**DESIGN & HISTORIC REVIEW COMMISSION – November 2, 2017**  
**STAFF REPORT**

<b>APPLICATION TYPE:</b>		<b>CASE:</b>	
River Corridor Approval		RCC17-28: Arredondo	
<b>SYNOPSIS:</b>			
This is an application for River Corridor Approval for a single-family residence located on the outskirts of the River Corridor. The applicant is requesting to construct a new carport, front entry porch, and back porch, a remodeling of the front wall window detailing, and for additional paving areas to the driveway and driveway approach.			
<b>LOCATION:</b>		<b>LEGAL DESCRIPTION:</b>	
909 Crenshaw Street; generally located approximately 85 feet east of the intersection of South Browning Street and Crenshaw Street		Being 0.224-acre in the Spencer Addition No. 2, being the west 35 feet of Lot 3 and the east 30 feet of Lot 2, Block R	
<b>SM DISTRICT / NEIGHBORHOOD:</b>	<b>ZONING:</b>	<b>FLU:</b>	<b>SIZE:</b>
SMD District #3 – Harry Thomas Fort Concho East Neighborhood	Single Family Residential (RS-1)	Neighborhood	0.224-acre

<b>APPLICATION TYPE:</b>		<b>CASE:</b>	
River Corridor Review		RCC17-29: Fastsigns	
<b>SYNOPSIS:</b>			
A request for approval, as required per Section 12.06.003(b)(1) of the River

PROPOSED REMODELING

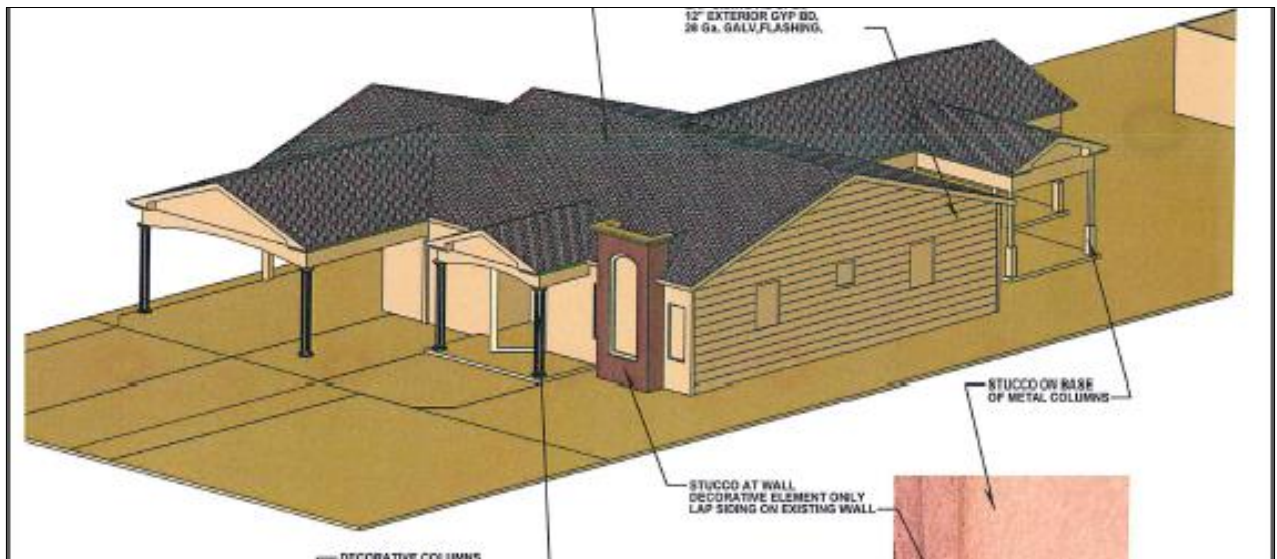
The RCMDP states that “a mix of building materials, both traditional and new, can blend a new building project into an existing neighborhood.” The applicant is proposing to incorporate the existing building materials into the new additions to his house. The result is that the applicant’s home will be architecturally consistent, and will combine a mix of materials that refresh the house and add to the curb appeal. The new window and door detail will further increase the blending of traditional and contemporary and will enhance the cohesive appearance of the new façade.

The RCMDP policies state that “quality finished materials should be used.” The applicant is proposing to use composite shingles that match the existing roof for the new additions. Decorative columns are also being added to the front porch that match the ones holding the carport in place. The overall look will be one of quality constituents with complementary colors.

1. The colors and materials of all items shall be consistent with the renderings approved by the Design and Historic Review Commission, and as revised by the Planning and Development Services Director.
2. The applicant shall obtain a Building Permit for all new construction as required.

**Renderings for Proposed Monument Sign**

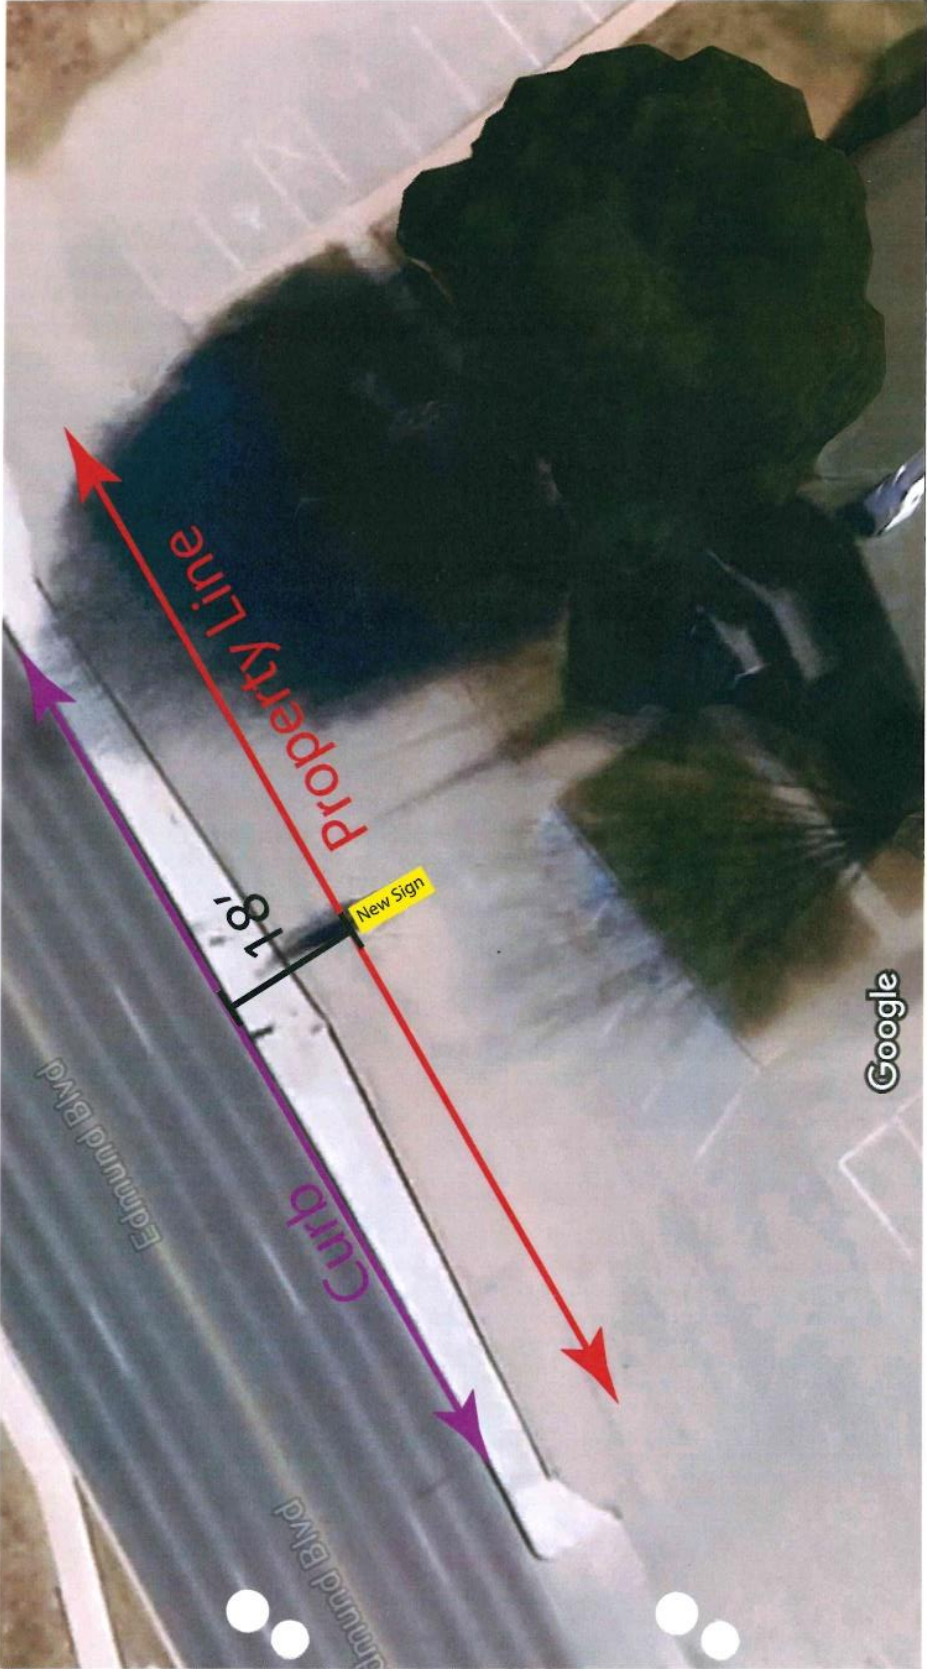
The RCMDP states that “Signs should be incorporated into the architecture of each building.” The selected red brick color and tan accent color are similar to colors found in the main church building. The sign architecture will also be similar to in scale to the main church.

The RCMDP also states that, “major signage should be enhanced through the use of simple but effective landscaping. Landscaping can help draw attention to the sign, and a simple layout will ensure that the sign is the focal point.” Staff is recommending that a landscape bed be constructed around the new monument sign to soften the visual impact.

The RCMDP lighting policy calls to “eliminate light trespass from building sites, improve night sky access, and reduce development impact on nocturnal environments.” The digital sign will be illuminated but Staff does not believe this sign will create any adverse impacts given it is located approximately 200 feet from the nearest residential property. However, Staff will recommend as a Condition of Approval that there be no spillover glare onto adjacent properties or the river.

1. The property owner shall remove parking spaces that no longer have the correct maneuvering area due to the new monument sign install and stripe a no parking lane connecting the two existing curb cuts.

2. The property owner shall construct a landscape bed with simple but effective landscaping to be approved by the Planning Director.
3. There shall be no glare of spillover illumination onto adjacent properties.
4. The colors and materials of all items shall be consistent with the renderings approved by the Design and Historic Review Commission, and as revised by the Planning and Development Services Director.
5. The applicant shall obtain a Building Permit for all improvements as required.

# Site and Lighting Plan

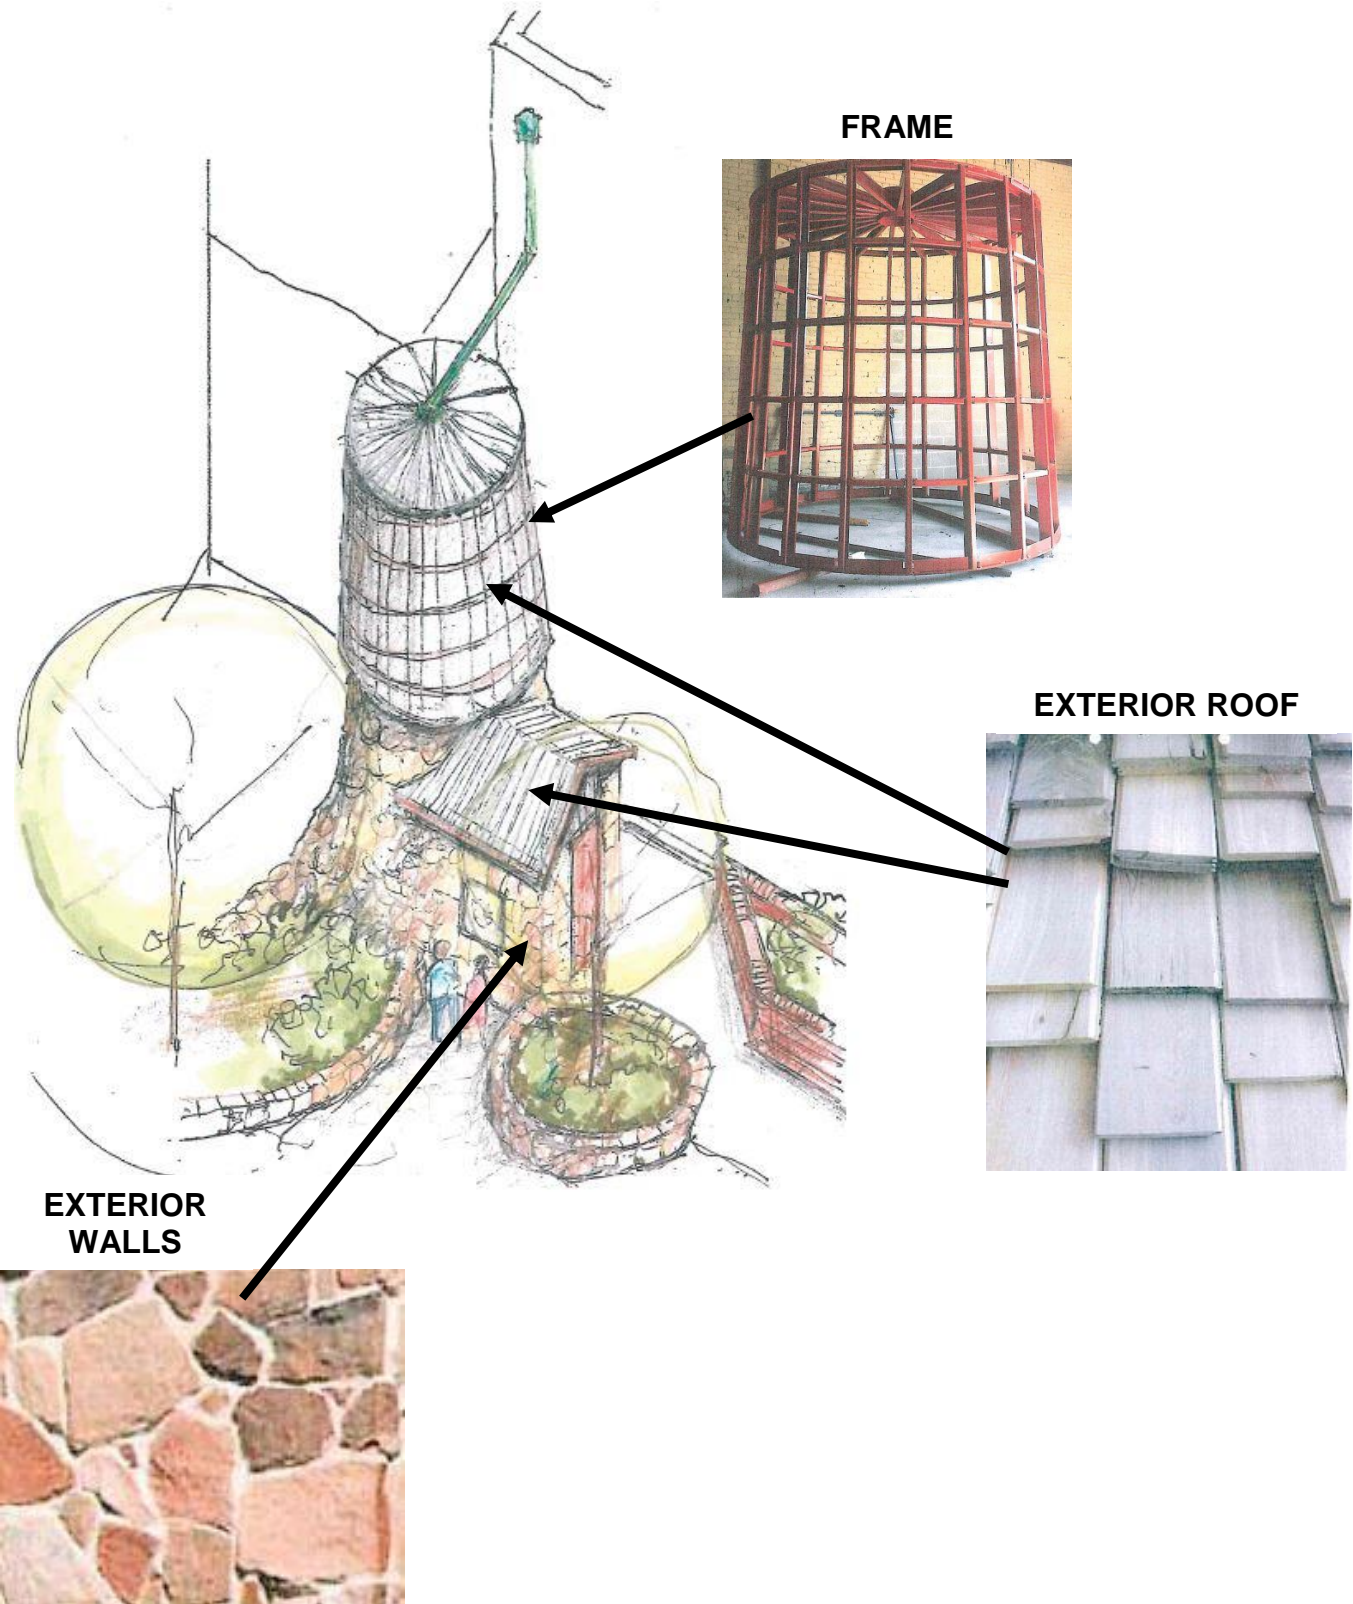
The original approval delineated four large pole light structures with ornamental wings to serve as entry features to the park and provide additional security. The applicant has decided to replace these structures with two new antique lamp post light structures painted black. These light poles will be approximately 12 feet in height and will contain LED lights. In addition, the applicant is also proposing a series of low voltage pathway (ground) lights throughout the site for additional security and night lighting for the park. These include 15 low voltage LED landscape spotlights; continuous POD lighting along the base of the new donor information wall; vertical LED tube lighting along the perimeter of the brick landscape planter walls; low voltage deck lighting around the statue area; and four brass bully well lights around the bronze statue itself. The lighting policy in the RCMDP states that "integrating lighting into a building can enhance the façade and architectural features, and provide for the safety of pedestrians, but should not result in glare and light spill" and "innovative and

attractive light fixtures are encouraged.” All of the lights proposed will be LED lights which can mitigate light spill, consistent with the lighting policy. The antique pole lights are consistent with other historical pole lights in Downtown San Angelo including those found at Santa Fe Park. All of the lights will provide additional security at night for visitors to the park. The surrounding area is predominantly commercial except for a residential building to the east. As a condition of approval, the Planning Division will require that should there be any spillover glare onto adjacent properties, that dimmers are installed on the lights.

5. Should there be any spillover glare onto adjacent properties, dimmers or shields may be required to be installed on the lights, as determined by the Planning Director. All television screens shall be turned off between the hours of 10:00 a.m. and 7:00 a.m.

## Reduced Pond Area, Rock Garden and Bronze Statue

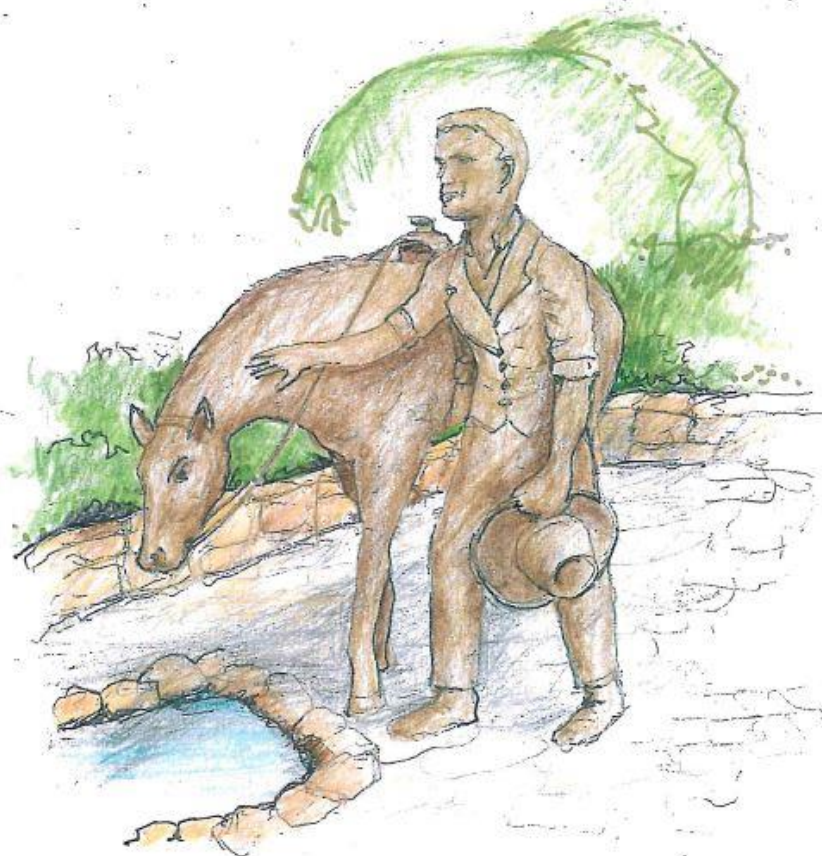
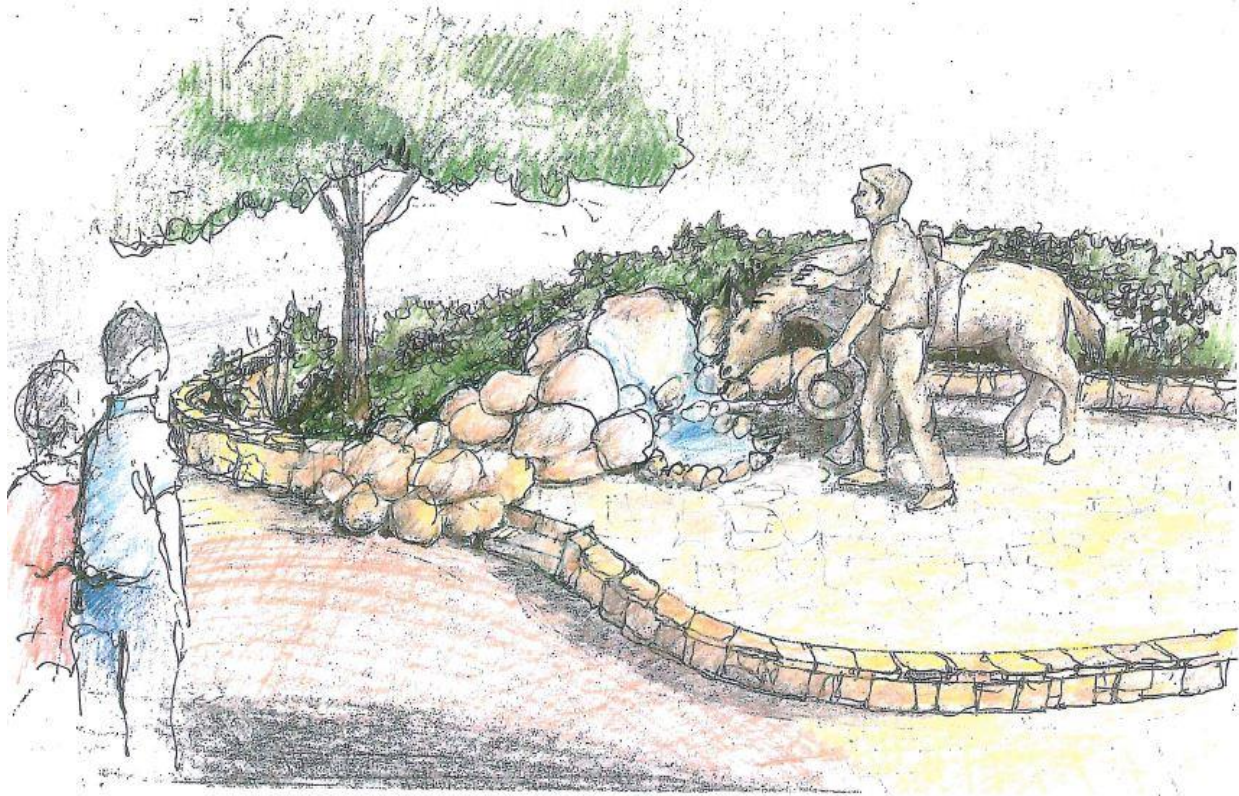
The applicant has submitted a revised site plan with a scaled-down water pond. The original water pond was approximately 50 square feet included a stepped-down water fall approximately three feet from grade at its tallest point. The new pond is at grade with no waterfalls and is approximately 12 square feet. The applicant indicates the reduced size pond will be more viable to maintain. It will have a small circulating water pump for the small pool of water. The remaining space will be filled with additional limestone rocks. Perennial vegetation will be provided around the limestone rocks for additional visual enhancement. The limestone rocks will be similar to the cut stone on the main building and surrounding buildings, utilizing quality, natural materials consistent with the RCMDP policies.

The applicant will maintain the same-size bronze rancher and horse statue in the same location next to the water pond. The statue will measure four feet wide, ten feet long and seven feet tall, and be of quality construction. Consistent with the previous approval, The natural bronze exterior will enhance the site, reflect the history of West Texas, and provide an attractive statue in the heart of historic downtown.

COMMUNITY BUILDING LEFT ELEV. BLDG. 'E'

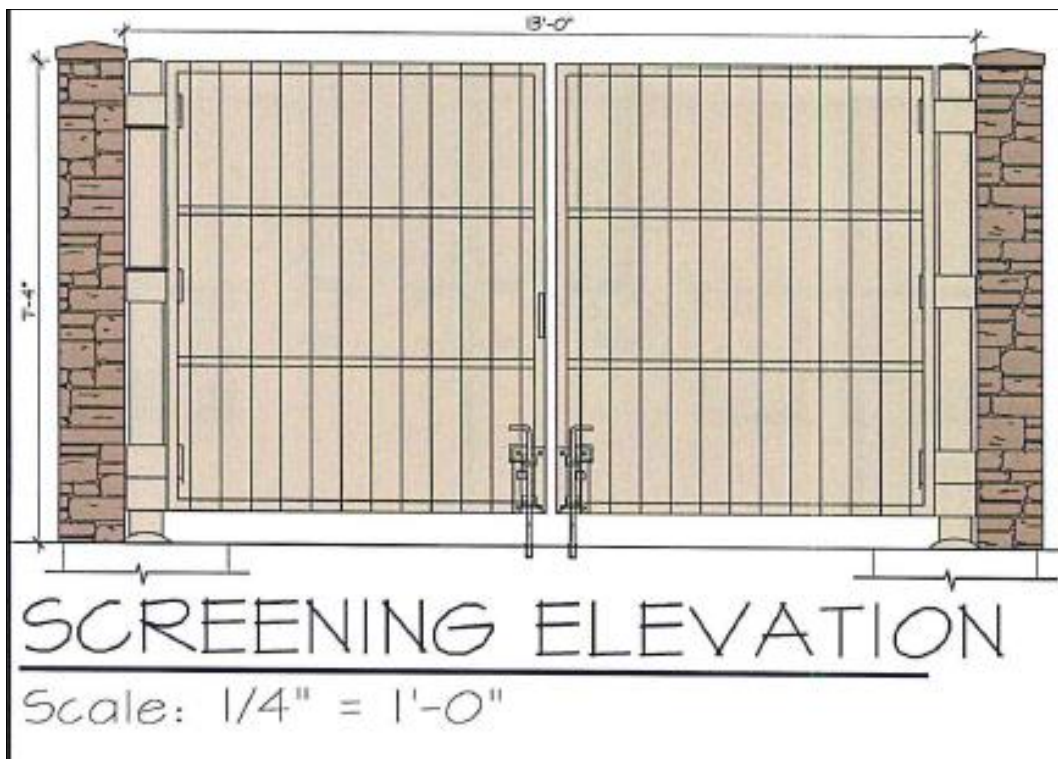
The RCDMP provides for multi-family to “look similar to large single-family houses,” and the elevations provided by the applicant show the architectural characteristics of newer homes. Façade shifts and articulation are incorporated in the buildings on all dimensions. While the buildings are all single story, the height and pitch of the roof allow for a vertical appeal that adheres to the characteristic rhythm of the development as a whole.

The RCMDP policies state that “building materials that convey a sense of permanence and quality are appropriate and are encouraged.” Stone and brick veneers are used throughout the development and lend a harmonious sense of place that matches the ambience of the Concho River. A muted color palette further complements the consistency of the development.

1. The colors and materials of all items shall be consistent with the renderings approved by the Design and Historic Review Commission, and as revised by the Planning and Development Services Director.
2. The applicant shall obtain a Building Permit for all new construction, as required.
